Project	IEEE 802.16 Broadband Wireless Access Working Group <http://ieee802.org/16>	
Title	Uplink MIMO/Cooperative MIMO Transmissions for Relay Station with Multiple Antennas	
Data Submitted	04-May-2007	
Source(s)	<p>Anxin Li, Xiangming Li, Hidetoshi Kayama, Daqing Gu</p> <p>DoCoMo Beijing Labs 7/F, Raycom Infotech Park A, No.2 Kexueyuan South Road, Haidian District, Beijing, 100080, China</p> <p>Ismail Guvenc, Moo Ryong Jeong, Chia-Chin Chong, Fujio Watanabe</p> <p>DoCoMo USA Labs 3240 Hillview Avenue, Palo Alto, CA</p> <p>D. J. Shyy</p> <p>MITRE 7515 Colshire Drive McLean, VA 22102, USA</p>	
	Voice: +8610-82861501 Fax: +8610-82861506 {lax,lixm,kayama,gu}@docomolabs-beijing.com.cn	
	Voice: 650-496-4726 {iguvenc, Jeong, cchong, watanabe}@docomolabs-usa.com	
	djshyy@mitre.org	
Re:	Call for Technical Comments Regarding IEEE Project P802.16j (IEEE 802.16j-07/013).	
Abstract	The document describes methods for supporting uplink transmissions of RS with multiple antennas.

Uplink MIMO/Cooperative MIMO Transmissions for Relay Station with Multiple Antennas

Figure 249b Mapping of data subcarriers for 3-antenna RS

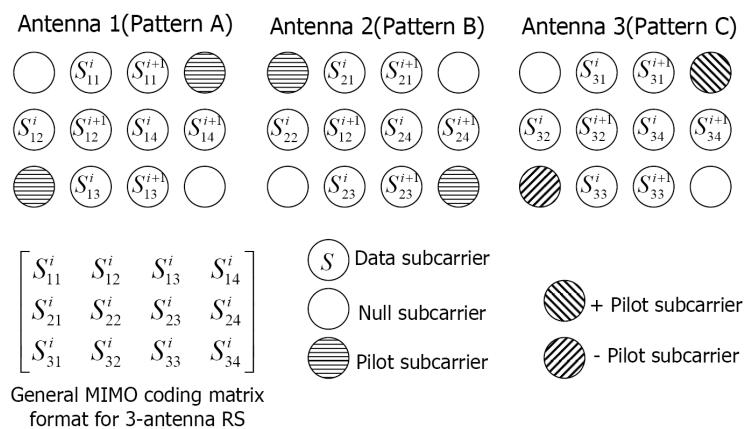
For RS using three antennas, the MIMO coding matrices defined in 8.4.8.3.4 shall be mapped to the tile according to Figure 249b.

Figure 249c Mapping of data subcarriers for 4-antenna RS

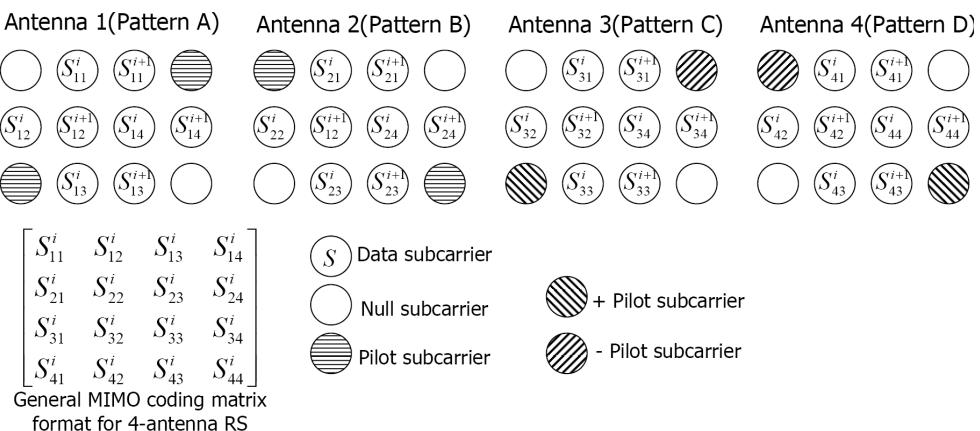
For RS using four antennas, the MIMO coding matrices defined in 8.4.8.3.5 shall be mapped to the tile according to Figure 249c.
